Peer Review of Demonstrating the Safety and Crashworthiness of a 2020 Model-Year, Mass-Reduced Crossover Vehicle (Lotus Phase 2 Report)

EPA-420-R-12-028
September 2012

SUBJECT: Peer Review of *Demonstrating the Safety and Crashworthiness of a 2020 Model-Year, Mass-Reduced Crossover Vehicle (Lotus Phase 2 Report)*, developed by Lotus Engineering, Inc.

Figure 17. Vehicle subframe deformation for NCAP test

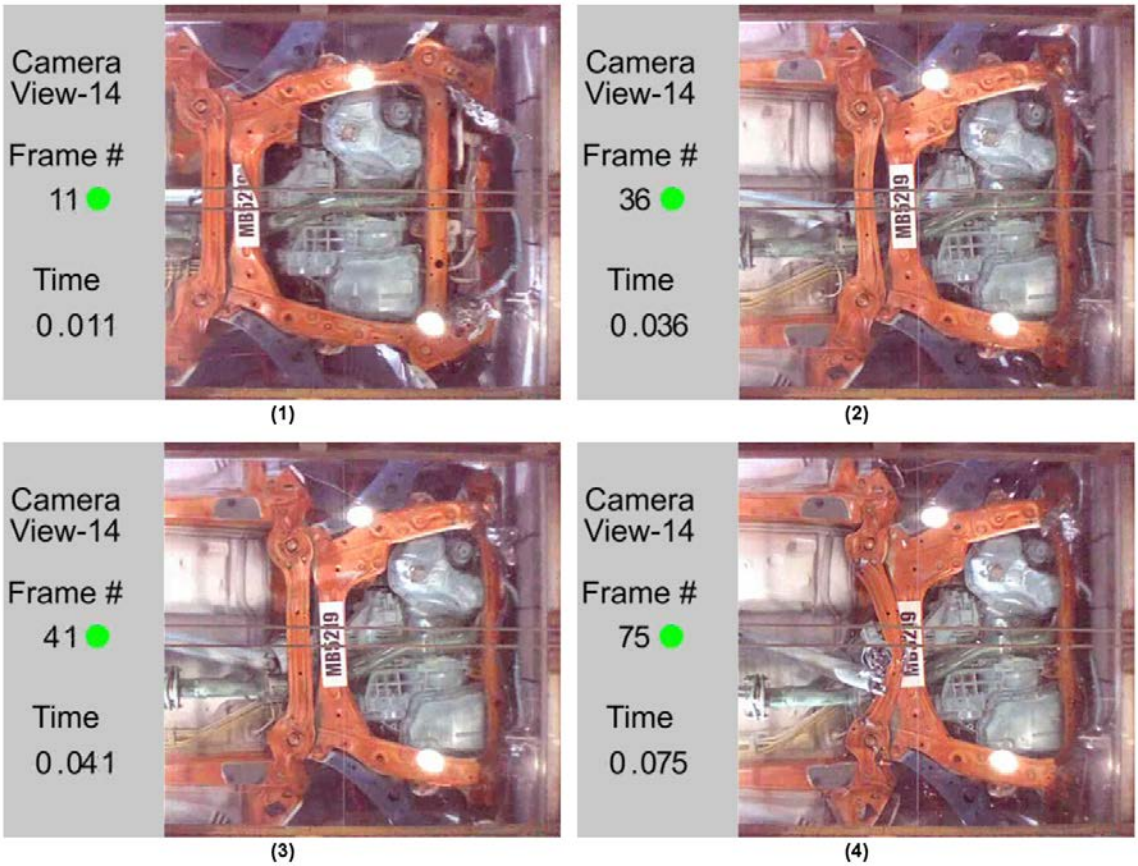
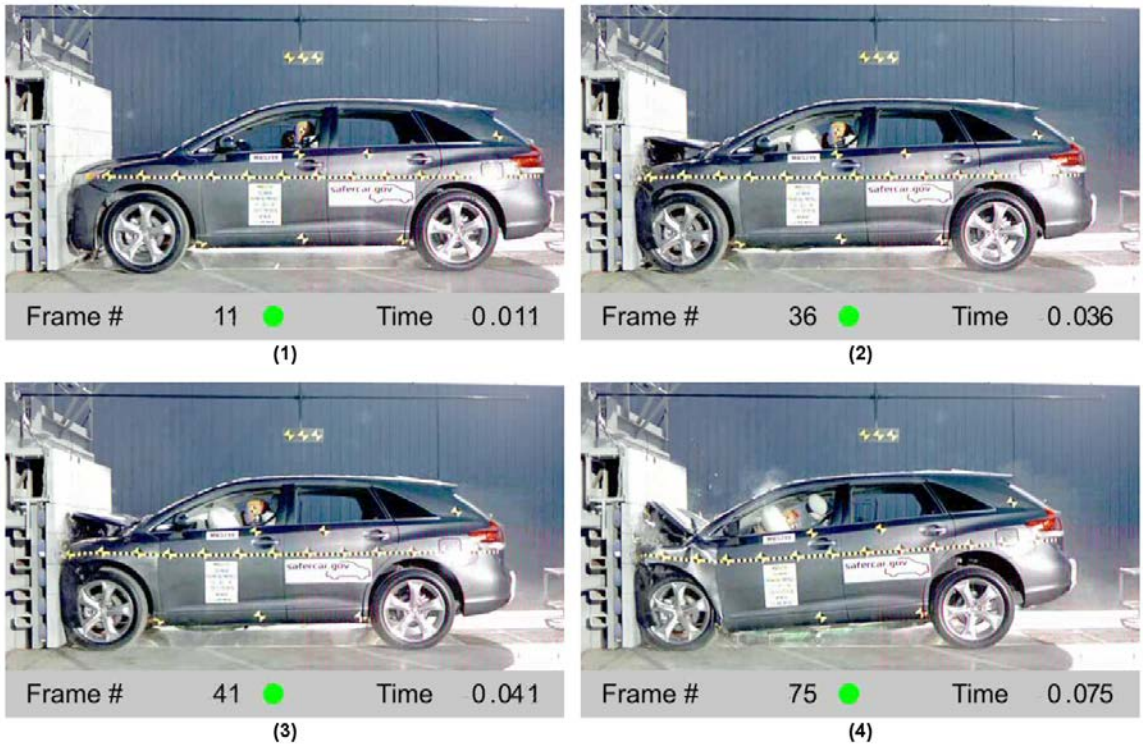
The subframe starts to rapidly break off of the vehicle floor around 40 ms, and therefore allows for additional deformation. In Lotus vehicle this connection remains intact so that it cannot contribute to additional crash length. The left side view of the test vehicle during crash at the same times is shown in Figure 18.

There is an obvious difference between the simulations and the tests. The developed lightweight model and the baseline vehicle do represent two different types of that share general dimensions, so that the differences in the responses can be large. However, diving down during impact is so common across the passenger vehicles so that different kinematics automatically raises questions about the accuracy of the suspension system and the mass distribution. If such kinematic outcome was a design objective, than it can be stated in the tests.
